Change Requirements of Backfill Material for Electric Distribution Only Trenches

AFFECTED DOCUMENT

Numbered Document 038193 “Minimum Requirements For the Design and Installation of Electric Conduit, Insulated Cable, and Facilities”

Figure 2
Secondary/Service or Streetlight Trench:
Minimum Covered Depth from Top of Conduit
is 24 inches

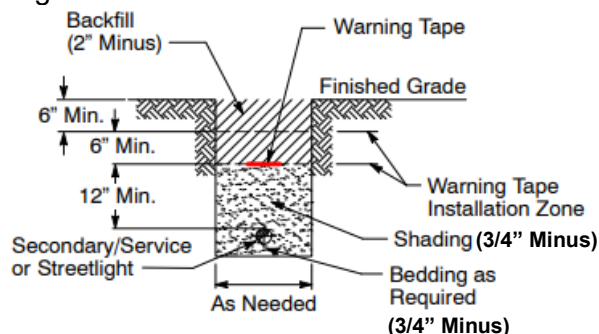
- 3.9 The native soil particle size allowed in the shading and bedding layers is $\frac{3}{4}$ " maximum, per Figure 2 and 3 below.
